## Climax TR-36 extension request

**Re: TR-36 Adequacy Review Response – Climax Mine Permit No. M-1977-493**

The purpose of this letter is to provide additional information requested in DRMS's August 3, 2023, TR-36 Adequacy Review. The Division's comments are in italics with Climax's response following.

# 5 DAM SEEPWATER COLLECTION AREA SECONDARY CONTAINMENT SYSTEM

| 5 DAM SEEPWATER COLLECTION AREA |  | Climax Molybdenum Climax Mine |             |
|---------------------------------|--|-------------------------------|-------------|
|                                 |  | DRAWING NO.                   | 6-807-00102 |

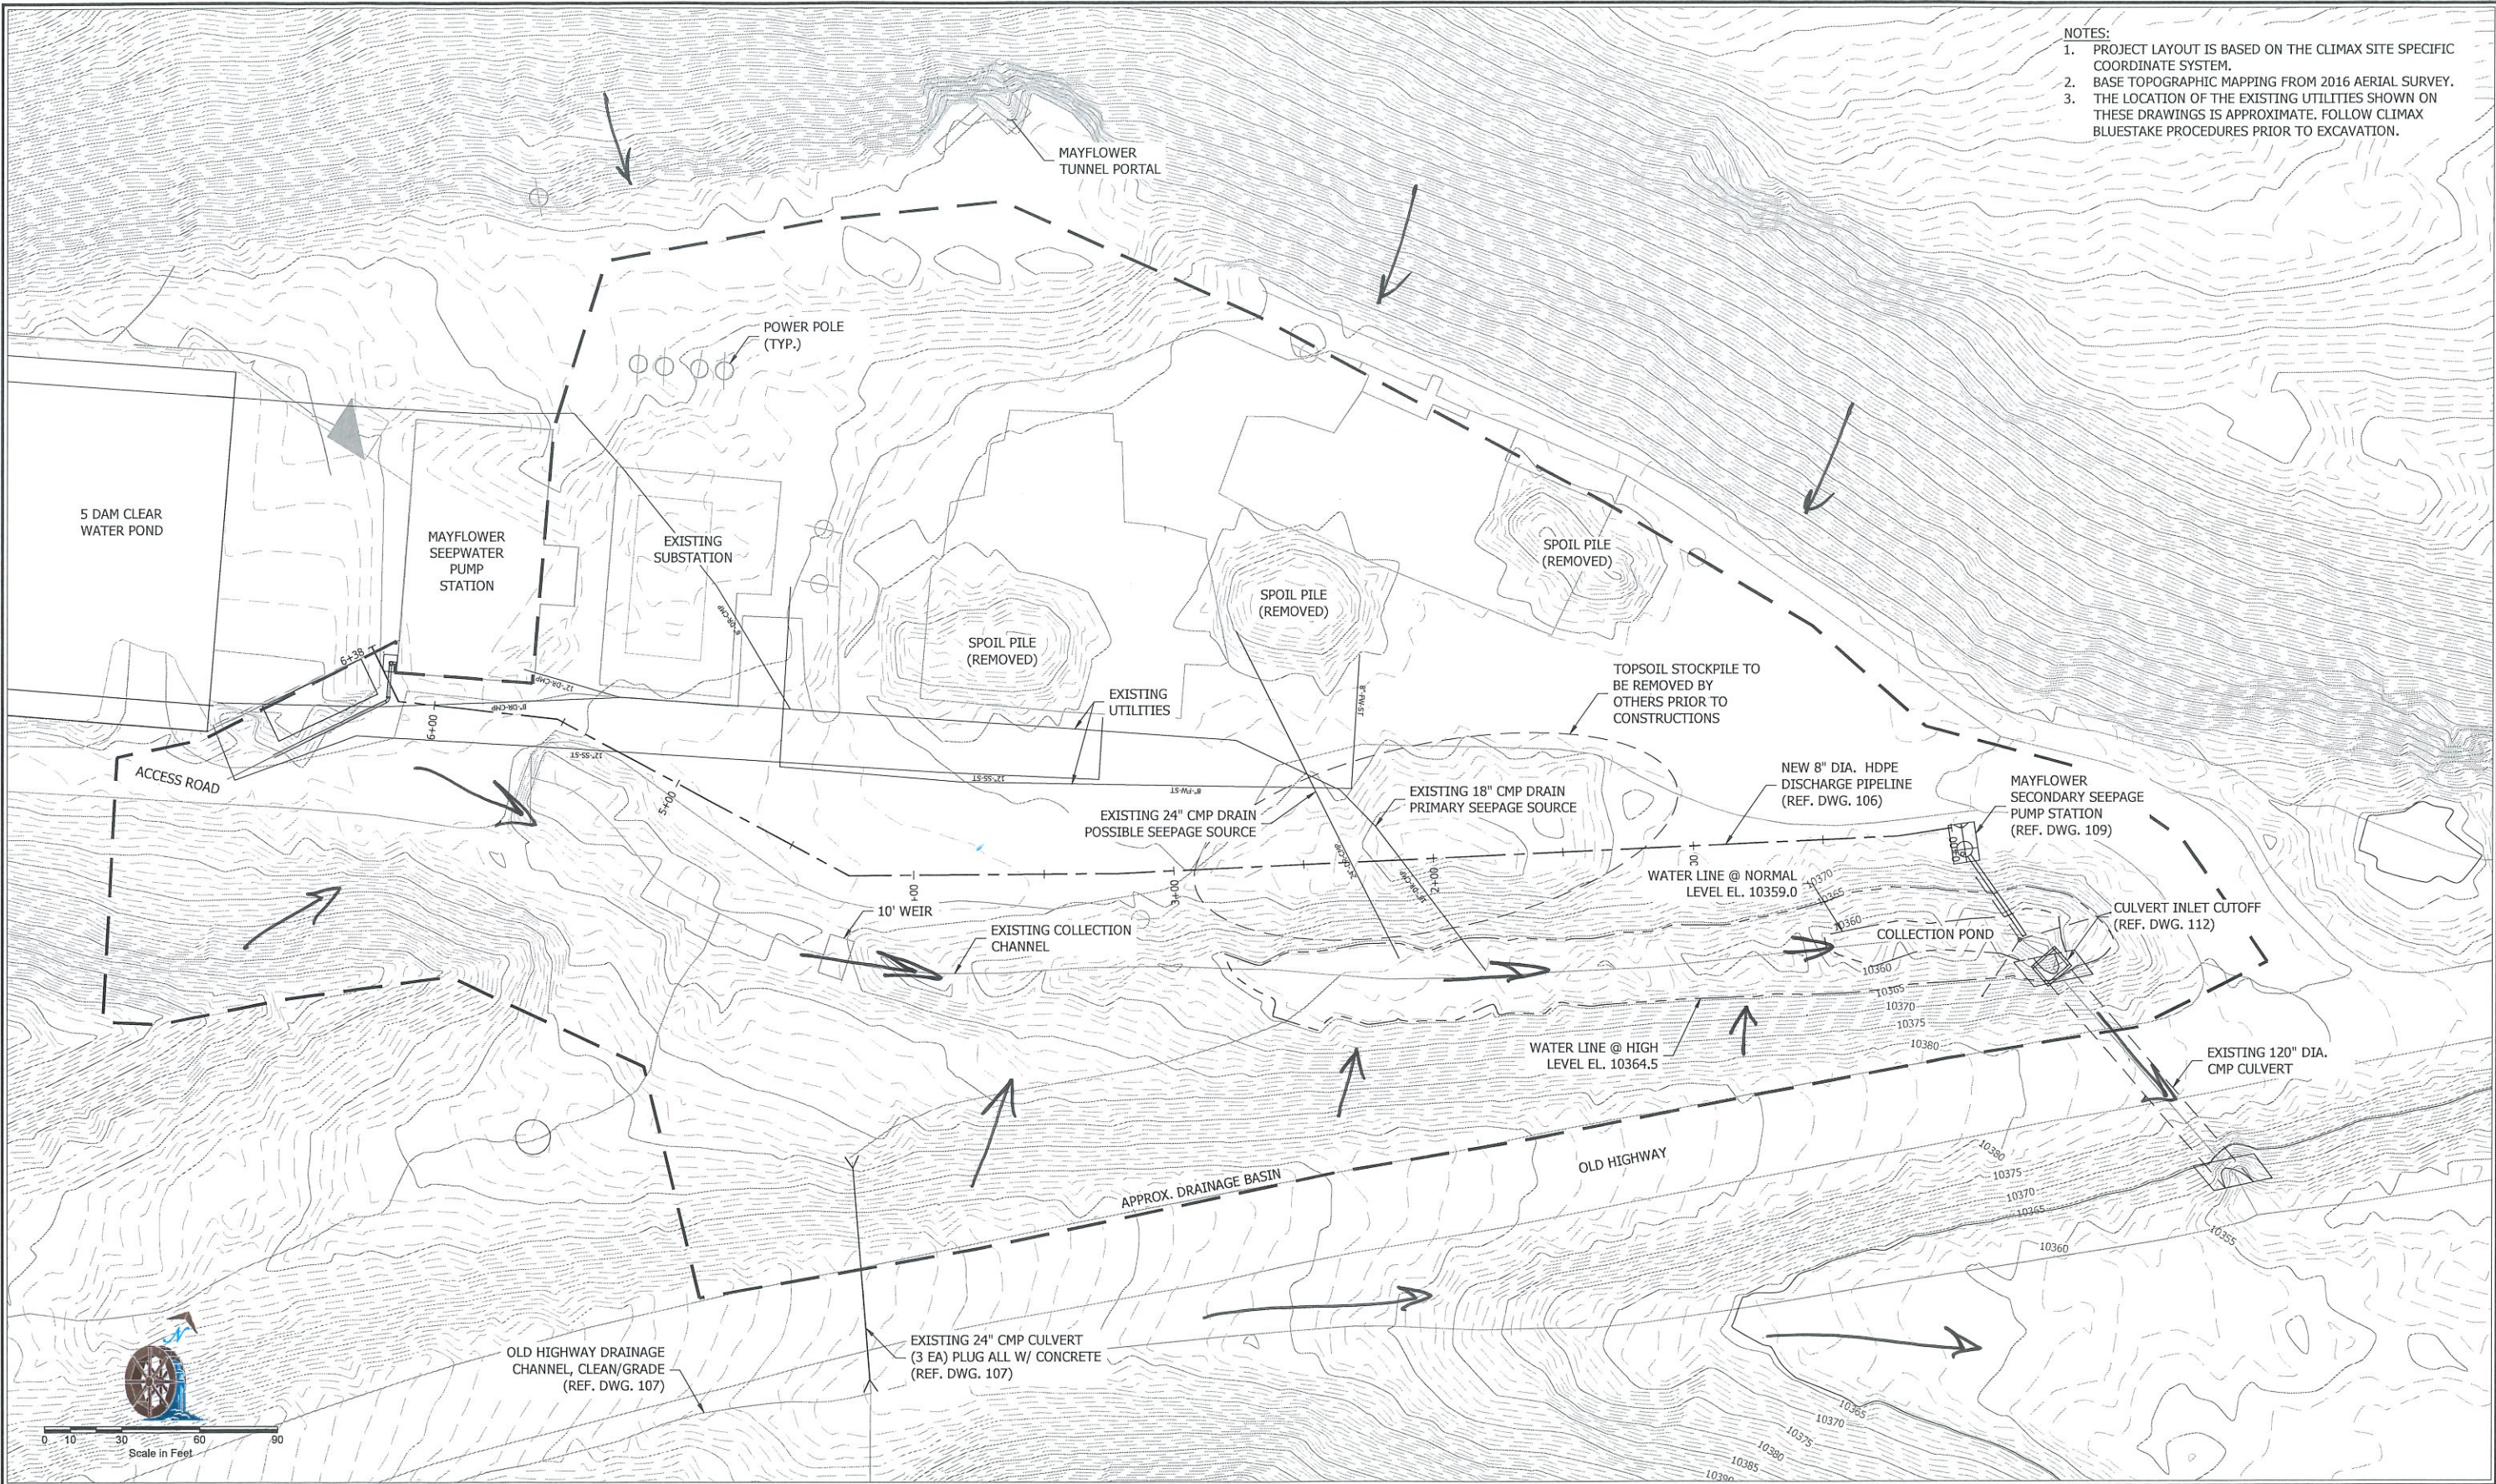
4. *Please state where the three spoil piles and one topsoil pile which need to be relocated will be placed. (Per drawing #6-807-00102 and #6-807-00106) What is the estimated volume of the three spoil piles needing to be removed?*

The three spoil piles depicted on Drawing Nos. 6-807-00102 and 6-807-00106 are artifacts from when the topography was last flown and have been previously removed. The topsoil pile has also been relocated to adjacent to 5-Dam in preparation for spreading onto an un-reclaimed area of the dam face in 2024.

| 5 DAM SEEPWATER COLLECTION AREA    |  |  | Climax Molybdenum Climax Mine |       |                |
|------------------------------------|--|--|-------------------------------|-------|----------------|
| PLAN AND DETAILS                   |  |  | ACCEPTED BY                   | ...   | 6-807-00107    |

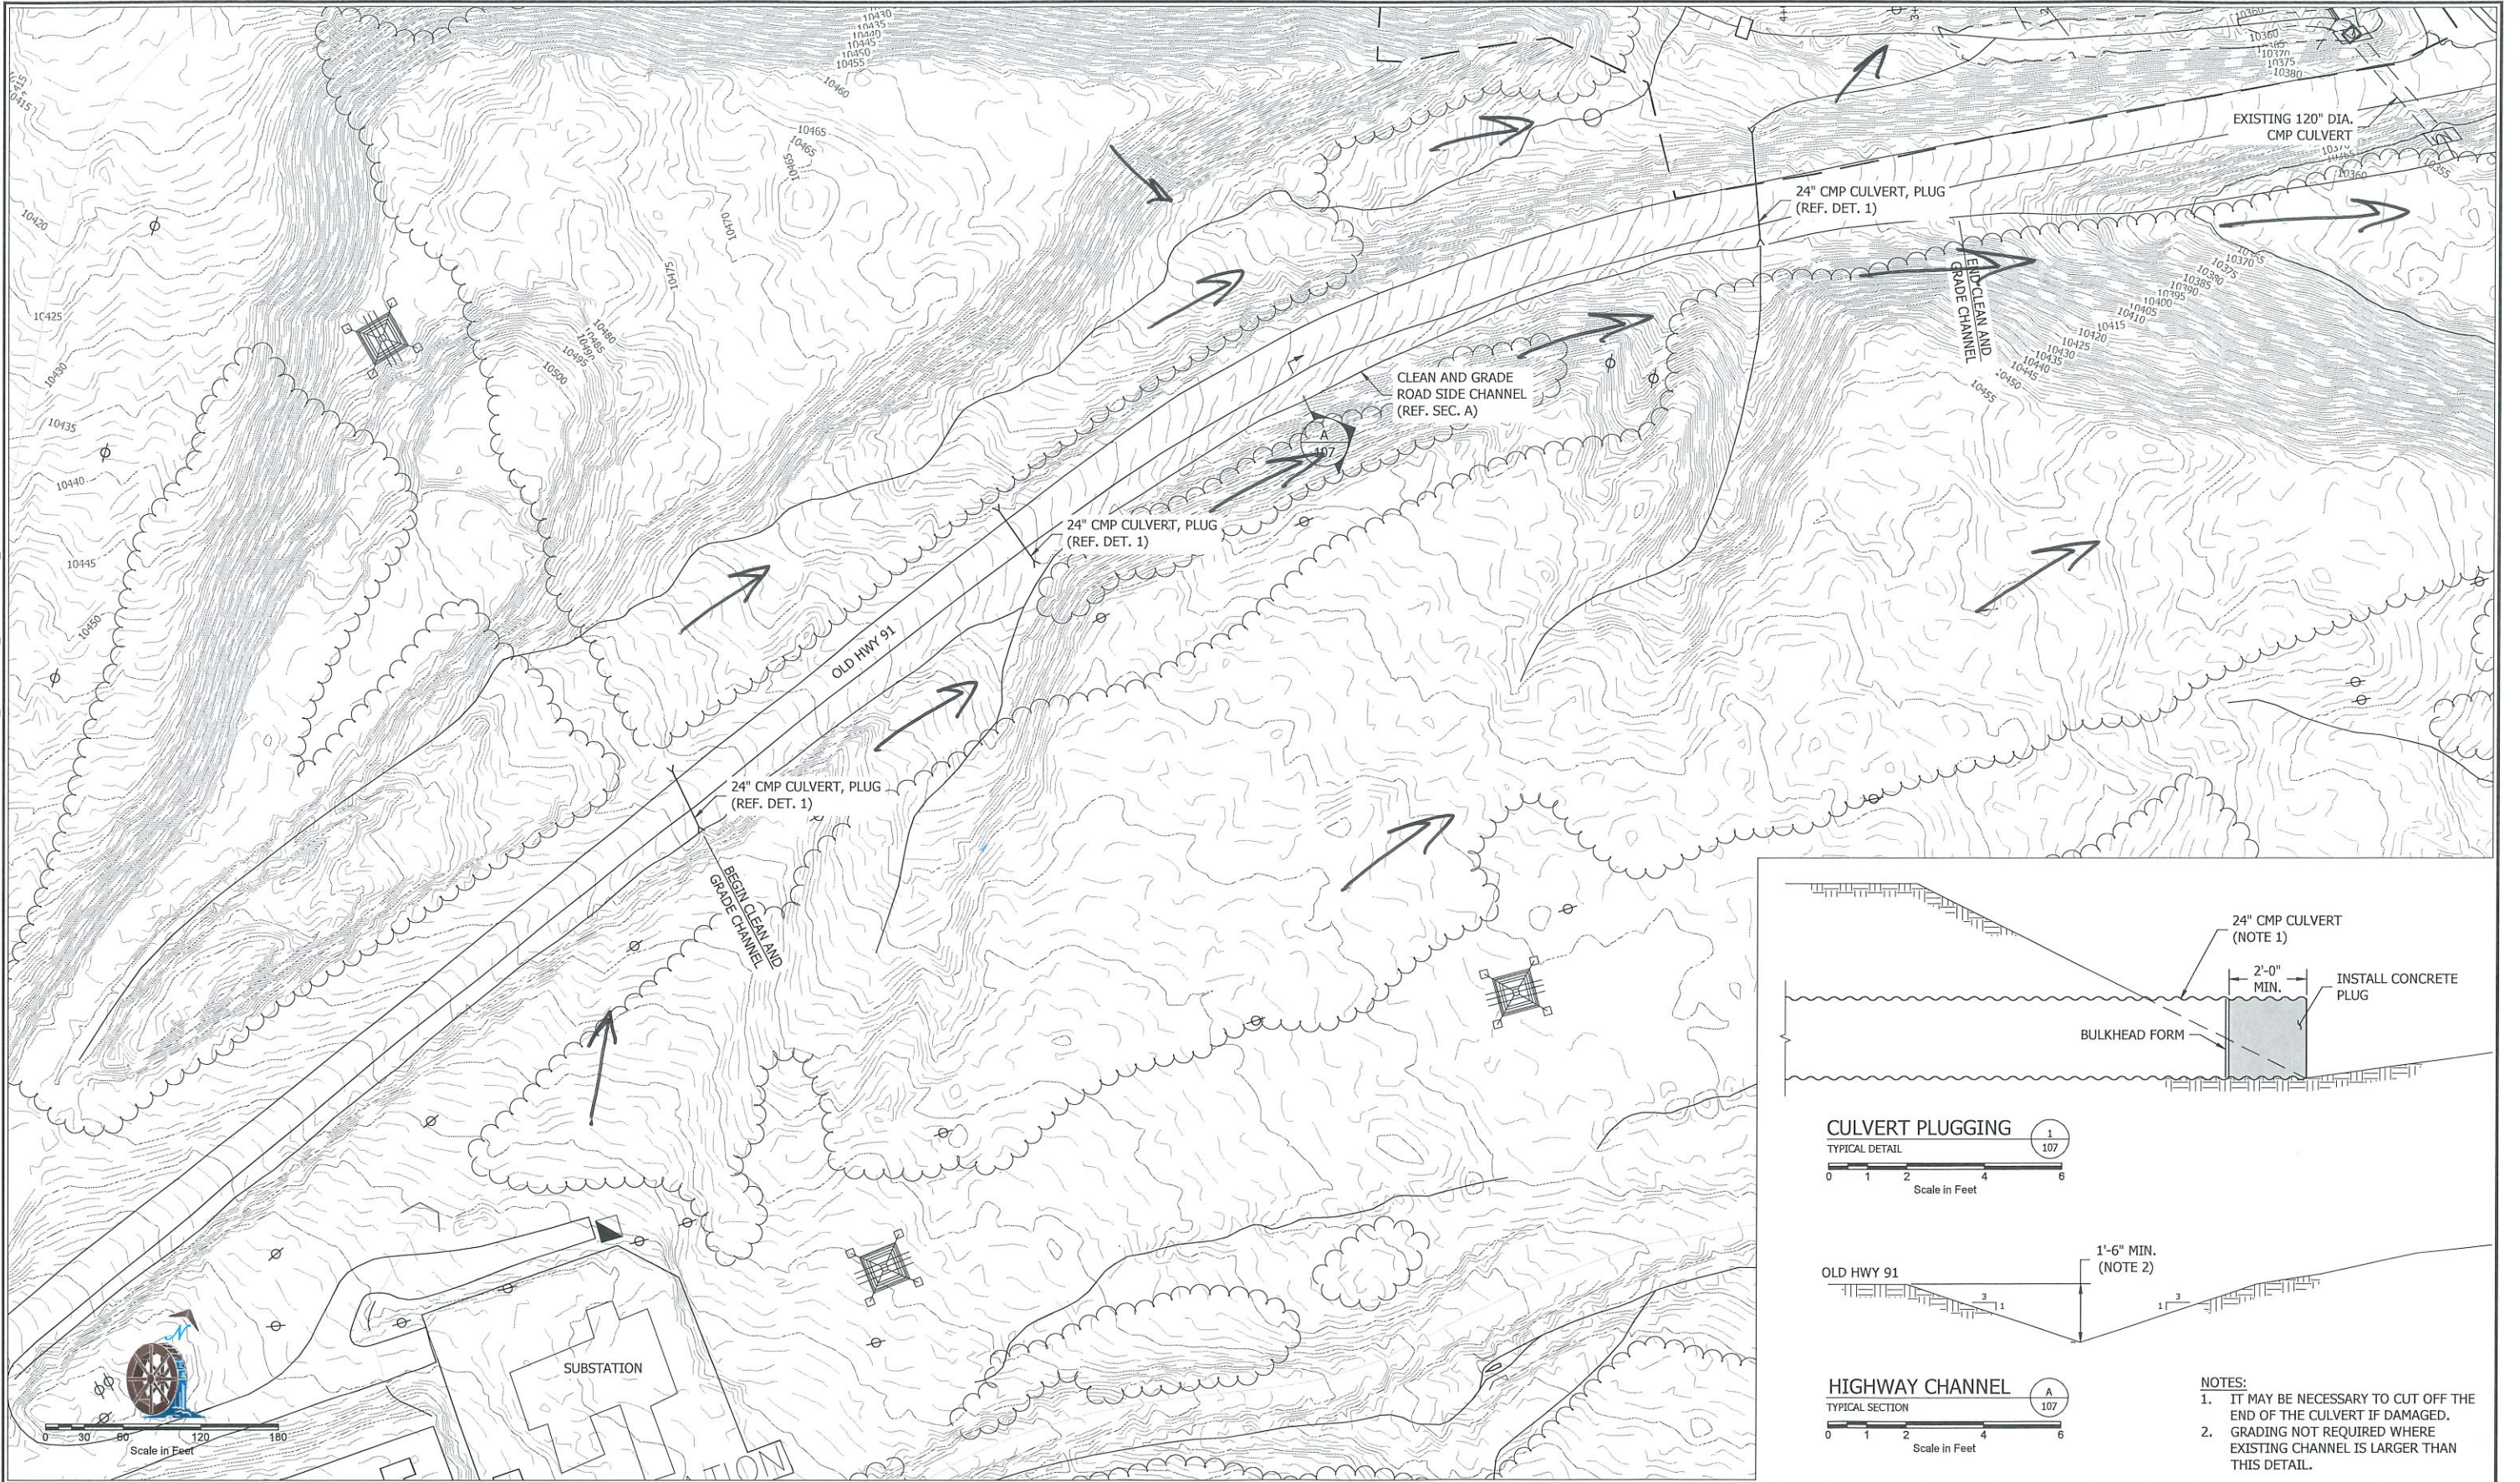
13. *In the Division's August 2, 2023 meeting it was described that the proposed 24" corrugated HDPE culvert on the south side of the collection channel and pond is no longer necessary. Please revise all applicable drawings removing that feature from the design. Please also explain how the modification better manages stormwater within the updated narrative.*

Please see Drawing No. 6-807-00107, which depicts the three 24-inch diameter corrugated metal pipe (CMP) culverts under Old Hwy 91 that will be plugged. This will ensure surface water runoff from the south side of Old Hwy 91 stays on the south side of this road. This water will be conveyed in an existing road ditch/channel until it enters the main channel below (or downgradient) of the 120-inch diameter CMP outlet. This will reduce the amount of natural (unimpacted) flow from entering the seepage capture system.

This improvement description is included in the updated project narrative. The revision has been reflected in the design drawings, too.
